Access Compliance Report

Public Rights-of-Way

(Curb Ramps)

Intersection ID: 32314	Main Street: CAMDEN TRAIL CT	Cross Street: NEW PROVIDENCE LN	Location: SE
ADA ID: D82FE7BC59C4	Ramp Type: PerpDiag	Initial Pass/Fail: Pass	Overall Compliance: No
		Severity Score: 20

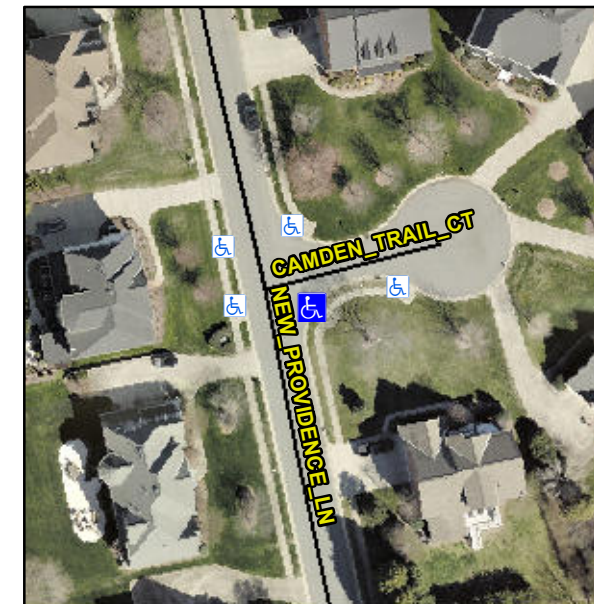
R304.2.1, R304.2.2-Perp, R304.3.2-Para, R304.5.3, R305

Compliance	Description	Data	Compliance	Description	Data
N/A	Ramp Length (in)	97.0	Yes	Ramp Slope (%)	6.8
Yes	Ramp Width (in)	48.0	Yes	Ramp XSlope (%)	0.6
N/A	Flare Type LT	None	N/A	Flare Type RT	N/A
N/A	Flare Slope LT (%)	N/A	N/A	Flare Slope RT (%)	N/A
N/A	Flare Traversable LT?	N/A	N/A	Flare Traversable RT?	N/A
No	Landing Length (in)	N/A	No	DWS Provided?	No
No	Landing Width (in)	N/A	N/A	DWS Contrast?	No
No	Landing Slope (%)	N/A	N/A	DWS Length (in)	N/A
No	Landing X Slope (%)	N/A	N/A	DWS Full Width?	No
N/A	Landing Curb? (Y/N)	No	N/A	DWS Offset (in)	N/A
N/A	Shared Landing?	No			
Yes	Gutter Ponding?	No	Yes	Gutter Slope (%)	3.3
Yes	Gutter Lip Ht (in)	0.0	Yes	Gutter X Slope (%)	1.3
N/A	Painted X Walk1?	No	N/A	Painted X Walk2?	No
	X Walk 1 Direction	To N		X Walk 2 Direction	To W
N/A	X Walk 1 Width (in)	N/A	N/A	X Walk 2 Width (in)	N/A
	X Walk 1 Slope (%)	0.7		X Walk 2 Slope (%)	1.9
	X Walk 1 X Slope (%)	2.0		X Walk 2 X Slope (%)	0.6

Remove & Replace Curb Ramp With Two New Directional Ramps or Equivalent.
